Technical Bulletin

Number: 033
Date Issued: 11/03/03
Expiration Date: 11/03/04

Subject/Key Words:	Robot and Queue Product Sensor Relay Wiring Change			
Classification:	<input checked="" type="checkbox"/> Informational	<input type="checkbox"/> Mandatory	<input type="checkbox"/> Safety Alert	<input type="checkbox"/> PM Impact
	<input type="checkbox"/> Warranty Impact	<input type="checkbox"/> Purchase Parts	<input type="checkbox"/> No Charge For Parts expires ___/___/___. Reference this TB# when ordering NC parts.	
Applicable Akrion Procedures:	None			
Parts/Reference Documents:	Drawings 202879 and 202880			
Attachments:	None

Solution: Below is the original relay configuration and pin labeling:

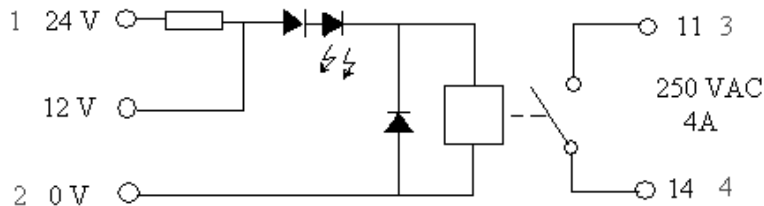
Issue: Efezor Brand Sensors (202908) used for product detection on both GAMA and Rearmount wet station robots use a 4 amp, 24VDC relay (RLY1B0065) in their circuit. This relay had a specific pin configuration and associated schematic printed on its side. This pin configuration and schematic were also included on drawings 202879 and 202880 issued with the kits for upgrading sensors from older SICK sensors to the newer Efezor sensors.

At some unknown time, the relay vendor began supplying a new relay for this associated part number with a different pin configuration. These changes have not been incorporated into the drawings and have caused confusion in the field.

Below is the new relay configuration. The original 1, 2, 3, and 4 wire/pin designations are shown in red. Wire per this illustration
